**METROPOLITAN GOVERNMENT OF NASHVILLE AND DAVIDSON COUNTY**

**STAFF RECOMMENDATION**  
**1818 Wildwood Avenue**  
**July 17, 2013**

**Application:** Demolition  
**District:** Belmont-Hillsboro Neighborhood Conservation Zoning Overlay  
**Council District:** 18  
**Map and Parcel Number:** 11704013600  
**Applicant:** Manuel Zeitlin, architect  
**Project Lead:** Robin Zeigler, robin.zeigler@nashville.gov

<p><b>Description of Project:</b> The applicant proposes to demolish a contributing house in the Belmont-Hillsboro Neighborhood Conservation Zoning Overlay.</p>	<p><b>Attachments</b> <b>A:</b> Photographs <b>B:</b> Site Plan <b>D:</b> Elevations</p>
<p><b>Recommendation Summary:</b> Staff recommends disapproval of demolition of this property based on economic hardship, finding that the purchaser will be creating a self-imposed hardship by purchasing the property for more than its current value.</p>

Photo 7: At left end of front wall there is a  $\frac{1}{8}$ -inch wide crack in the brick veneer.

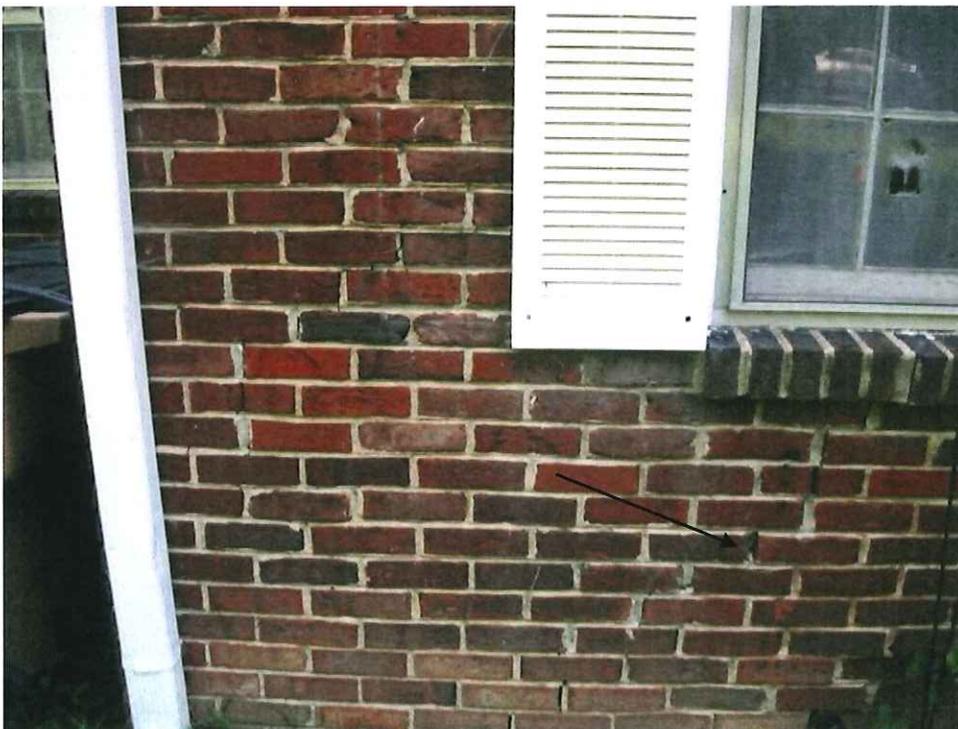
At the front stone foundation wall of the residence, the ground surface is close to the top of the foundation wall. The stone foundation wall has no steel reinforcement and has rotated from the lateral earth pressure pushing against it so it leans inward. The inward lean of the wall has created tension forces causing cracking of the stone front foundation wall (Photos 3 through 6) and brick veneer on the front wall (Photos 7 through 9). The inward lean of the front foundation wall has made the wall unstable. The danger for collapse is low but not negligible. A heavy rainfall event could cause collapse of the foundation walls if runoff penetrates into the basement. GEC recommends:

- The front foundation wall needs to be removed and replaced with a reinforced poured concrete or concrete masonry block foundation wall constructed on a reinforced

perimeter poured concrete strip footing. The wall construction should be compliant with the requirements of the 2006 IRC.

Photo 25: Same crack in Photo 24 viewed from outside residence.

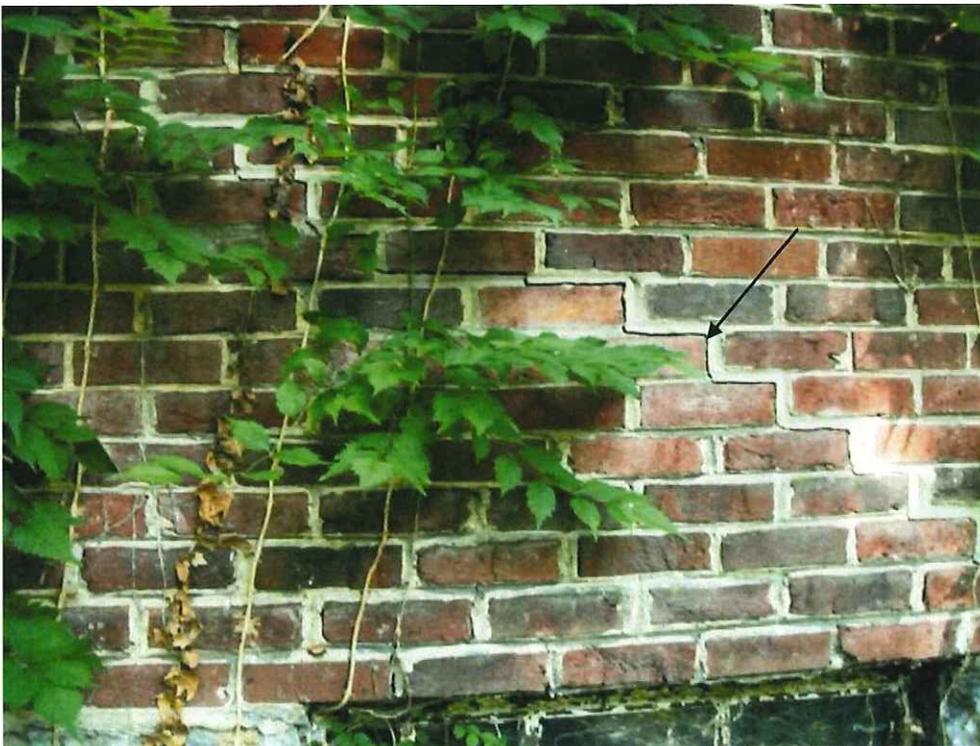
The forces pushing on the subfloor framing from the front foundation wall have pushed through the framing to the rear wall of the residence. The rear stone foundation wall is now leaning outward 1 to 2 inches at the top (Photo 20). The outward lean of the rear foundation wall has created tension forces causing cracking of the rear foundation wall and the rear ends of the side foundation walls (Photos 20 through 25) and cracking and bowing of the brick veneer on the rear foundation wall (Photos 26 through 28). GEC recommends:

- As previously discussed for the front foundation wall, the rear and side foundation walls need to be removed and replaced.
- The brick veneer on all sides of the residence has experienced cracking and bowing. The bowing cannot be corrected without removing the brick veneer and re-installing the brick with brick ties. Therefore, all the brick on the residence needs to be removed and replaced.
